UNITED STATES
NUCLEAR REGULATORY COMMISSION

SAFETY EVALUATION OF THE PROPOSED REPAIR

FOR THE VERMONT YANKEE CORE SHROUD

DOCKET NO. 50-271

VERMONT YANKEE - SHROUD WELDS
FIGURE 1

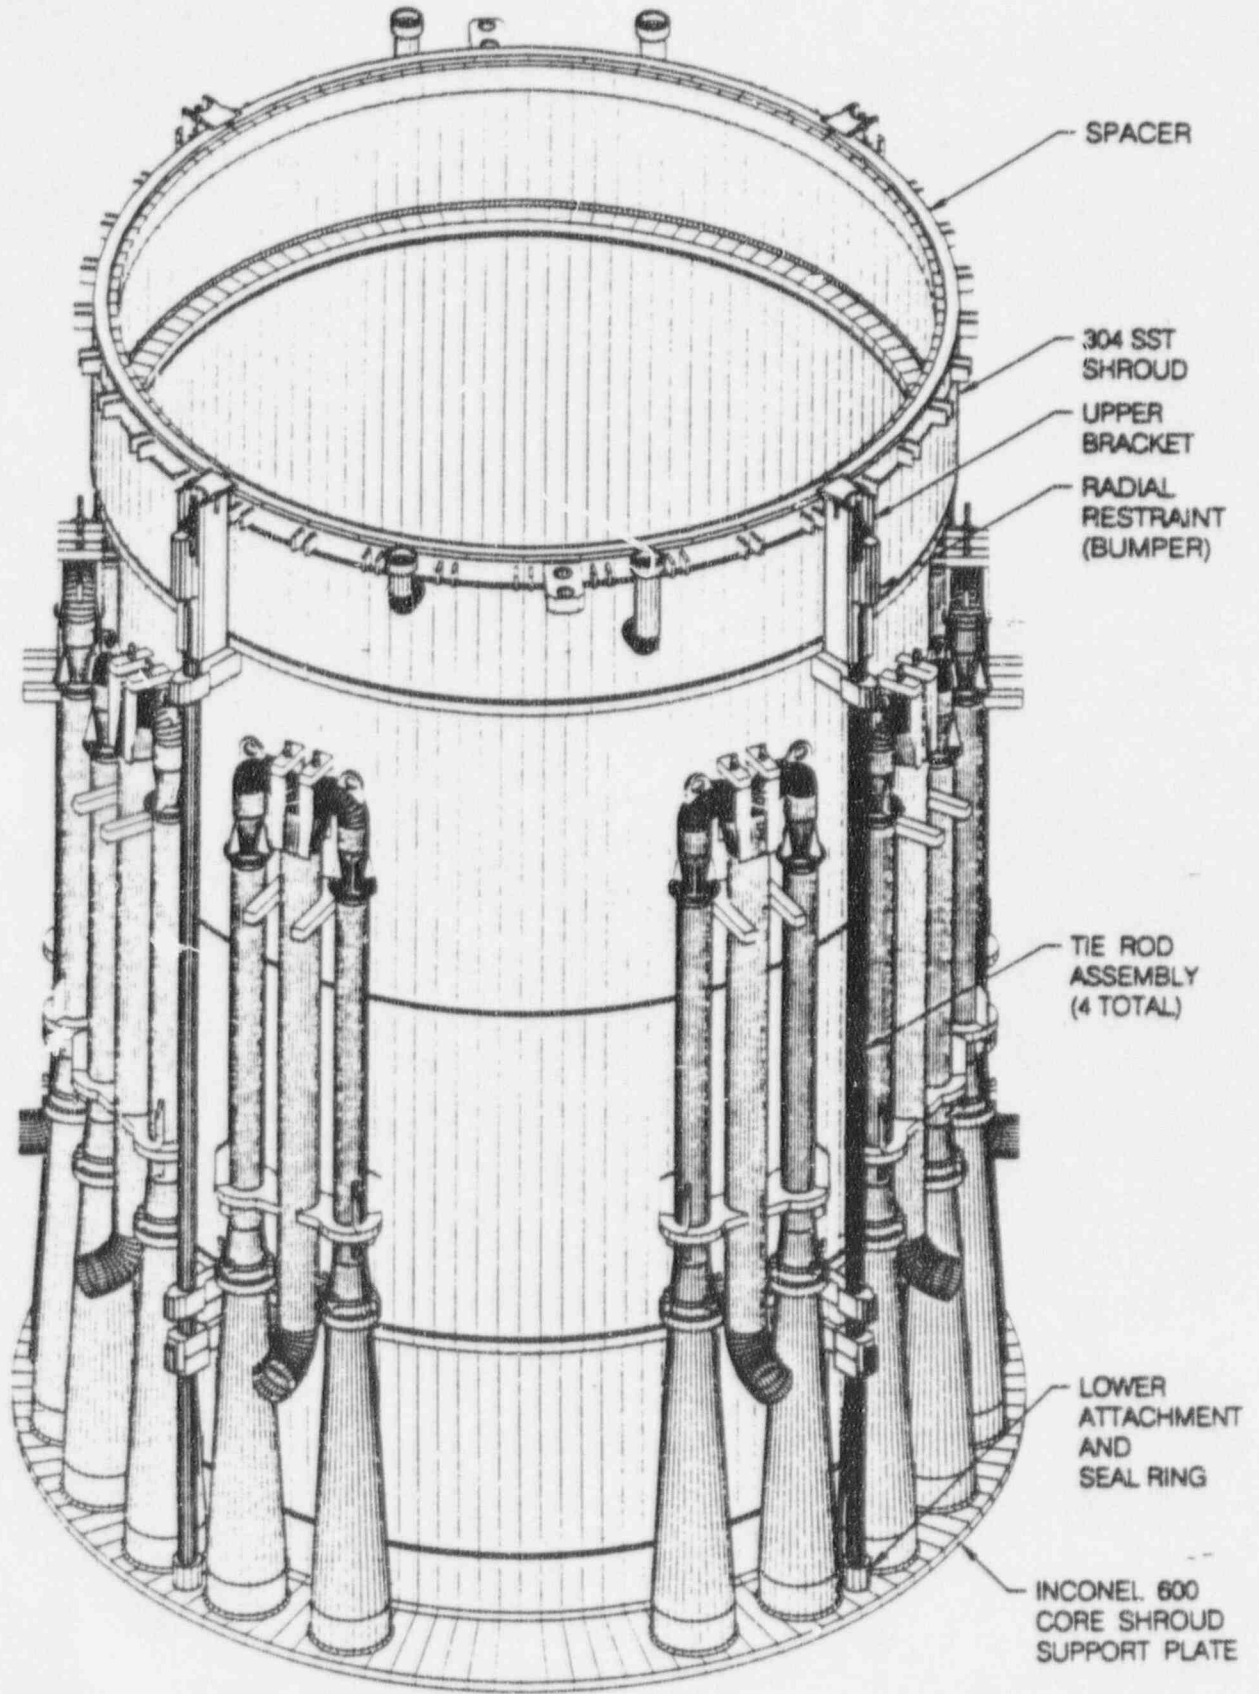
The VY core shroud repair is designed to replace all potentially-sensitized 304 stainless steel circumferential core shroud welds, i.e., H1 through H7 (See Figure 1). In addition, the modification can accommodate a complete failure of the H8 shroud weld considering the shroud support legs remain intact. The design life of the modification is 40 years.

Prior to installation of the shroud repair, VY will perform ultrasonic inspections of design reliant welds -- circumferential welds which provide an alternate path for the loads carried by the vertical welds. These inspections will cover portions of the vertical welds in the H3/H4, H4/H5 and H6/H7 shroud segments, the welds in the core support ring and welds H8 and H9.

The repair relies on portions of the vertical welds in the H1/H2 shroud segment to be intact. However, due to tooling limitations, it is not practical to ultrasonically inspect the vertical welds in the H1/H2 shroud segment. Therefore, rather than inspect these vertical welds, portions of circumferential welds H1 and H2 are designated as design reliant welds. Welds H1 and H2 were ultrasonically inspected in 1995. The results of these inspections will be used to demonstrate that sufficient design-reliant weld length exists. VY is considering H1 and H2 as design-reliant welds only for inspection reasons; the repair is designed as a repair to H1 and H2.

VERMONT YANKEE SHROUD REPAIR
FIGURE 2

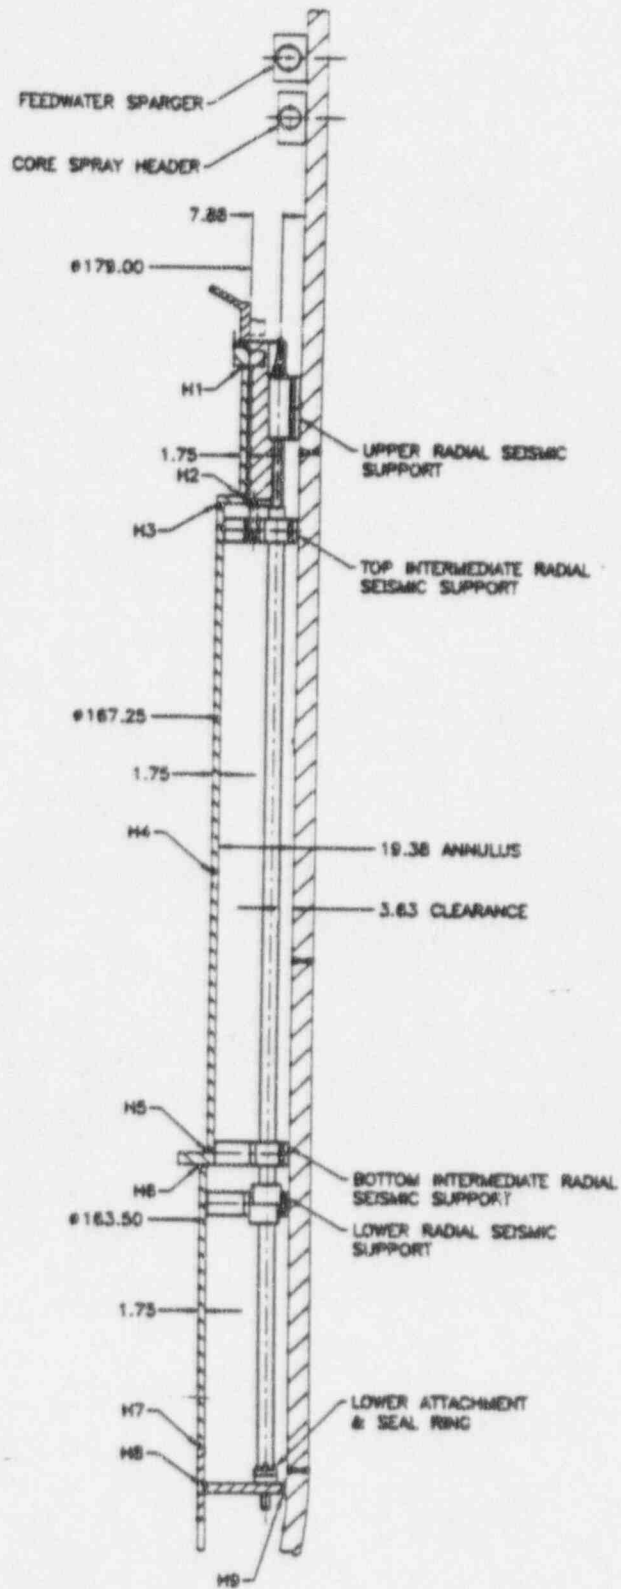
The core shroud modification design consists of four tie rod assemblies installed 90° apart in the core shroud/reactor vessel annulus. Each assembly consists of a tie rod, upper bracket, lower T-head and seal assembly, and four lateral restraints (see Figures 2 and 3). The assemblies, which are designed and fabricated as safety-related components, are used to maintain the alignment of the core shroud assuming all circumferential welds are cracked 360° throughwall.

A spacer ring is provided between the top shroud flange and shroud head. Cutouts are provided in the ring which allow the top bracket to be hung from the top shroud flange. The bracket is captured by the shroud head and the top lateral restraint. The bracket extends from the top flange to just above the H3 weld and provides support for the top lateral restraint. The tie rod passes through a hole in the top lateral restraint and bracket and is held by a nut. The tie rod extends down to the T-head at the shroud support plate.

The T-head is connected to the plate through a hole which is machined in the shroud support plate. The hole in the shroud support plate is sealed with a seal ring which is preloaded against the support plate. The seal preload is independent of the preload in the tie rod.

The radial restraints are solid stainless steel spacers which provide positive rather than spring-type lateral restraint of the core shroud. The restraints are integral with the tie rod assemblies. The restraints are installed based on field measurements to provide a small effective gap relative to the vessel wall. At the shroud elevations which support the top guide and core support plate, the effective gap is about 1/8-inch. At the upper intermediate and bottom radial restraint locations, a slightly larger effective gap of 1/2-inch is provided. As discussed later in this Safety Evaluation (SE), these gaps result in acceptable shroud displacements during all loading conditions.
